Project Name: New Town Section 3&6, Blk 14, Parcel E - Sentara Building
 County Plan No.: SP-125-06
 Stormwater Management Facility: Biotreatment
 BMP Phase #: I II III
 Information Package Received. Date/By: 1/22/08
 Completeness Check:
 Record Drawing Date/By: AES, Bob Cosby 1/21/08
 Construction Certification Date/By: AES, Bob Cosby 1/21/08
 RD/CC Standard Forms (Required for all BMPs after Feb 1st 2001 Only)
 Insp/Maint Agreement # / Date: # 080011785 5/6/08
 BMP Maintenance Plan Location: SP-125-06 sheet 8
 Other: _____
 Standard E&SC Note on Approved Plan Requiring RD/CC or County comment in plan review
 Yes No Location: _____
 Assign County BMP ID Code #: Code: PC213
 Preliminary Input/Log into Division's "As-Built Tracking Log"
 Add Location to GIS Map. Obtain basic site information (GPIN, Owner, Address, etc.)
 Preliminary Log into Access Database (BMP ID #, Plan No., GPIN, Project Name, etc.)
 Active Project File Review (correspondence, H&H, design computations, etc.)

Project Name: Sentara Building
Structure/BMP Name:
Project Location: New Town Block 14, Parcel E
BMP Location: New Town Block 14, Parcel E, Parking Lot
County Plan No.: SP - 125 - 06

GRADING & DRAINAGE & E

BIORETENTION AREA

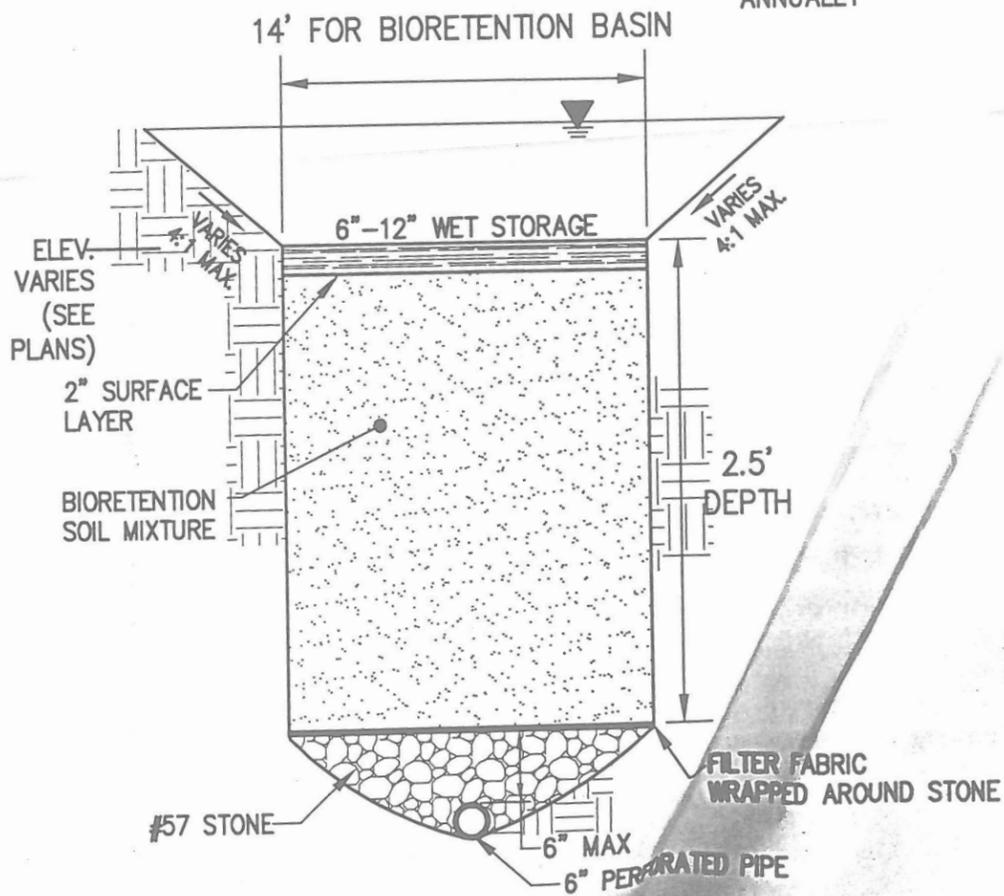
10. Bioretention area. The proposed area of bioretention does not appear capable of operating as stated in the design computations. This is due to the southern end appearing lower (FG = 111.10) in the plan than the inlet at the northern end (111.70). With the next submittal, provide appropriate information in the plan to convey to both the plan reviewer and the contractor that the measure has the required capacity (not to include the parking area), that all bypass flows have been directed to inlet SS# 4-11A, and that the basin can be constructed in the area provided.

FRENCH DRAIN DETAIL
NOT TO SCALE

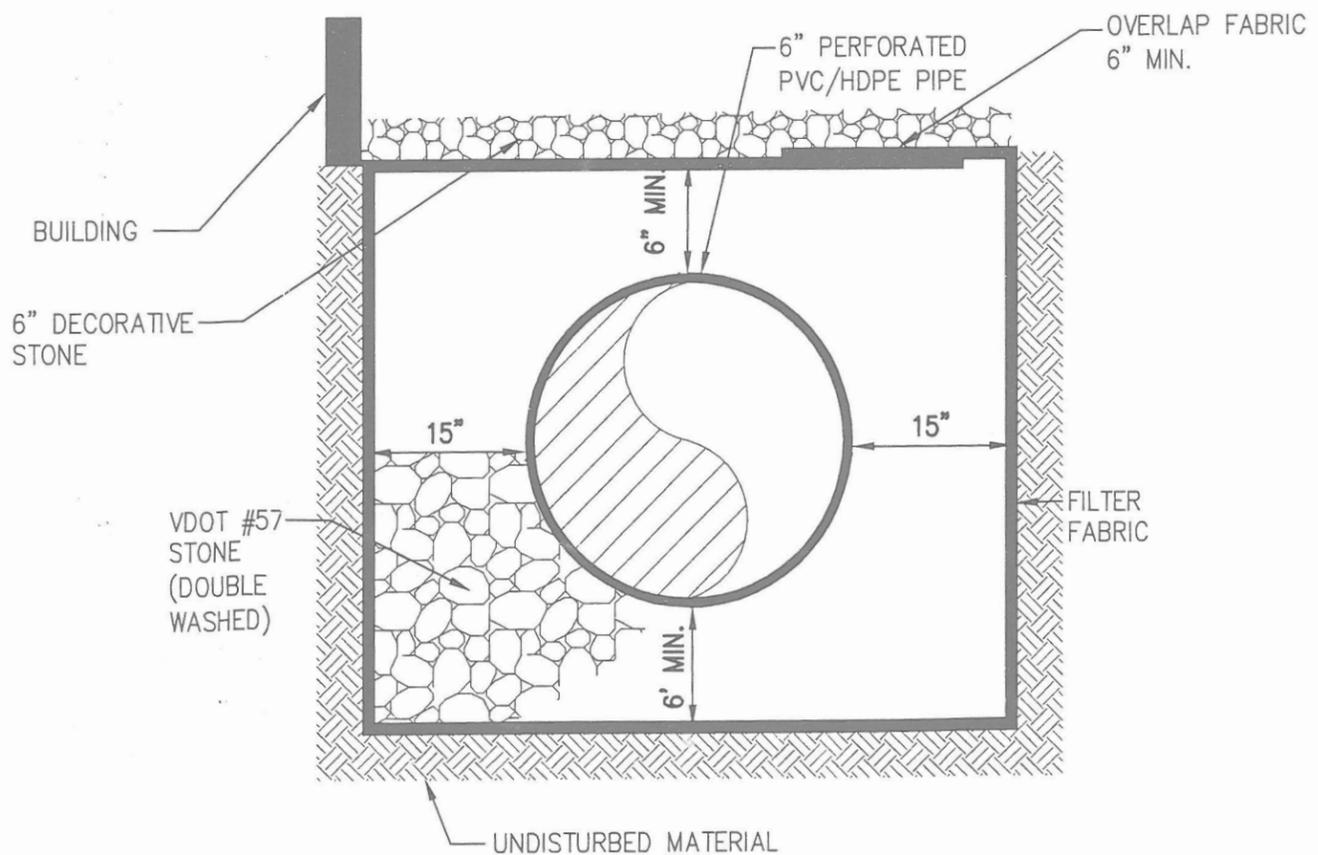
14. PVC Storm Drains. Provide appropriate information for the pipe to be installed in proximity to the proposed structure (HDPE, PVC, Schedule, Smooth wall, etc.), and provide and reference a detail for the apparent French drain as proposed around the proposed building. Detail should include stone type, trench dimensions, distance to foundation, placement of filter fabric, and location of drainage pipe.

Revised plans by adding trench drain detail to Sheet 7 "Notes and Detail Sheet".

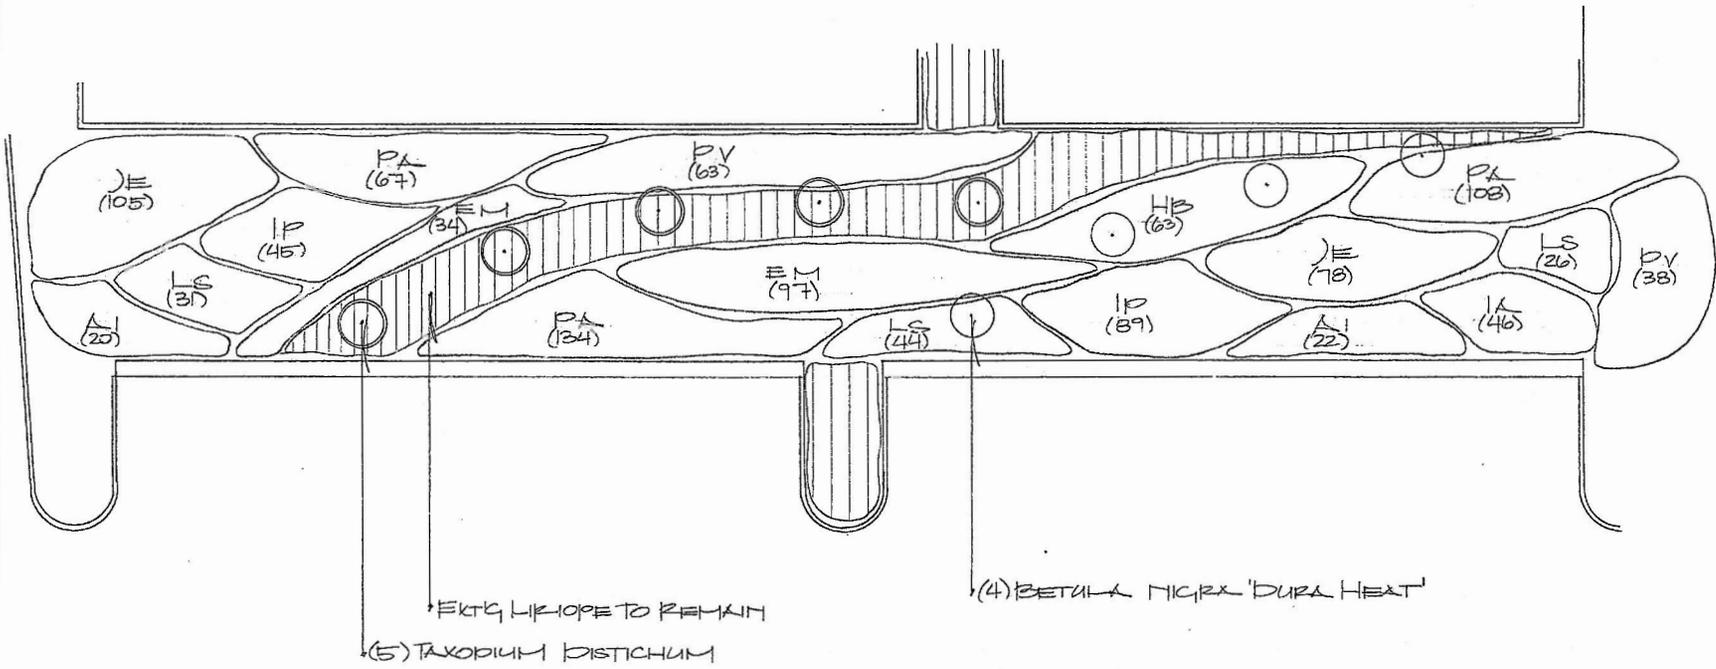
Just an FYI on this...we released the permit and surety on this project/BMP awhile ago 2008. County BMP ID Code is PC213. So technically they should be working with STW as a postconstruction BMP modification. However, from the plan amendment/permit side it would be us. If Scott W. is going to defer to us, I think the sketches are good enough for us to say ok to this without the need for a full blown SP amendment. The planting plan is well devised and an enhancement to that current. Again, except no cattails as proposed.

Leanne,
Attached are the revised bio-swale landscaping plans for our Sentara New Town, Williamsburg location. This should now meet with your approval. You will find in the attachments two "photo shopped" pictures that depict adding the additional 24 shrubs to the planting beds on both sides of the main entrance to the facility as well as the cattail material being swapped out as well. Please review and let me know if there are any other concerns that need to be addressed.

SENTARA NEW TOWN WILLIAMSBURG
 BIO SWALE PLANTINGS

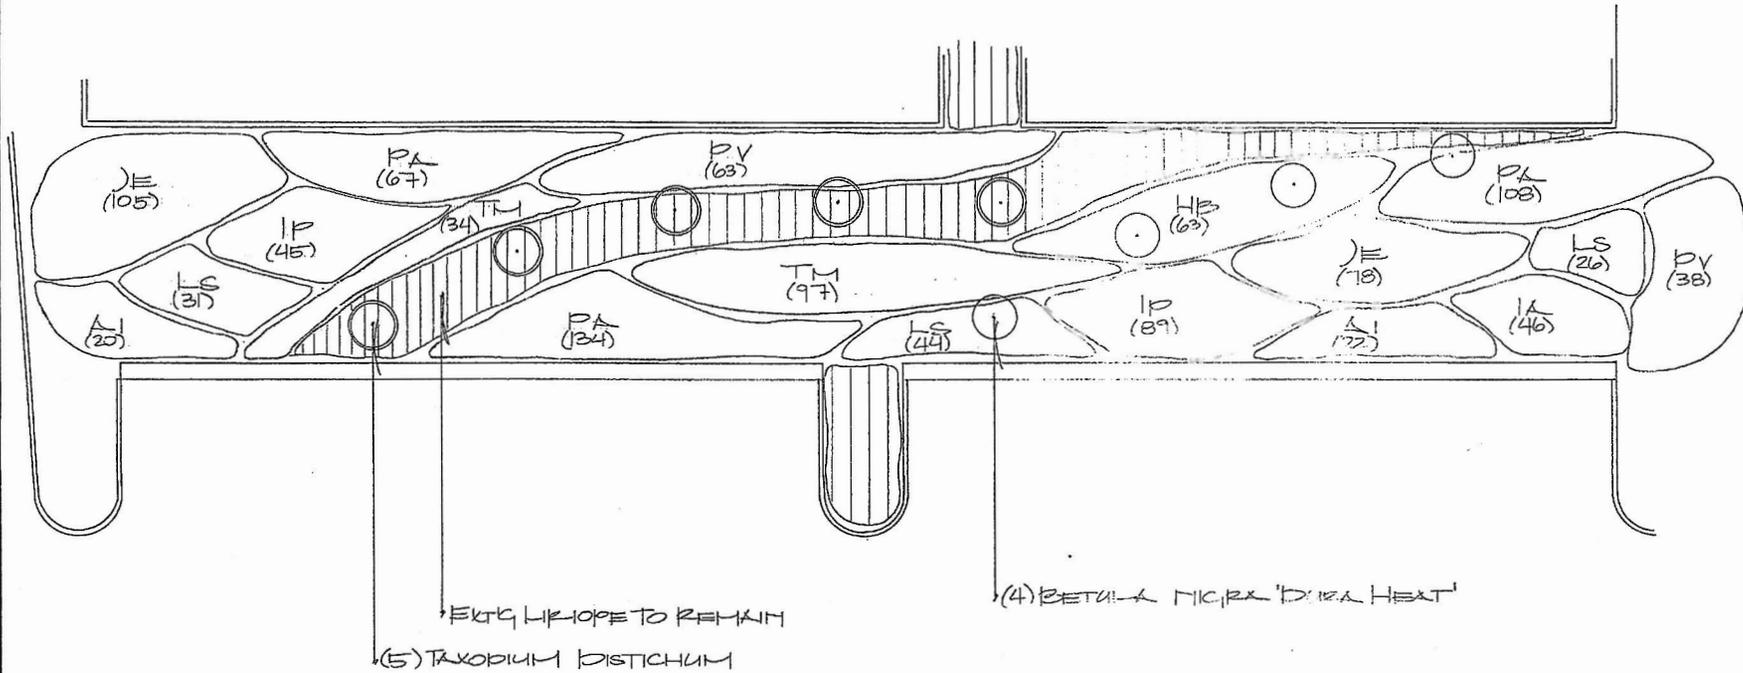
I talked with the owner about getting rid of the cattails and adding some shrubs so they still meet the parking lot ordinance. If these items are done, we're not going to require a site plan. I'll send you the revised drawing when I get it.

I've looked quick at this and it seems to be a very focused replanting of the bioretention basin using common plants used in such facilities. Would appear to be an enhancement compared to what we typically see. I would not use "cattail" though as they listed. This is very invasive in bioretention applications.

The plantings look fine to me, and I agree about cattails. If this was a change to the regular landscaping I would have to require an amendment. We allow substitutions to be approved over the phone, but when they change the overall design we require an amendment. But since it is within a bioretention facility, I'm not sure if that should be needed. I would like to defer to the ERP folks on that one.

Mike and Scott-
Here's the revised plan for the New Town Sentara bio-swale with the cattails replaced. Any issues with this revision or do you think it's good to go?
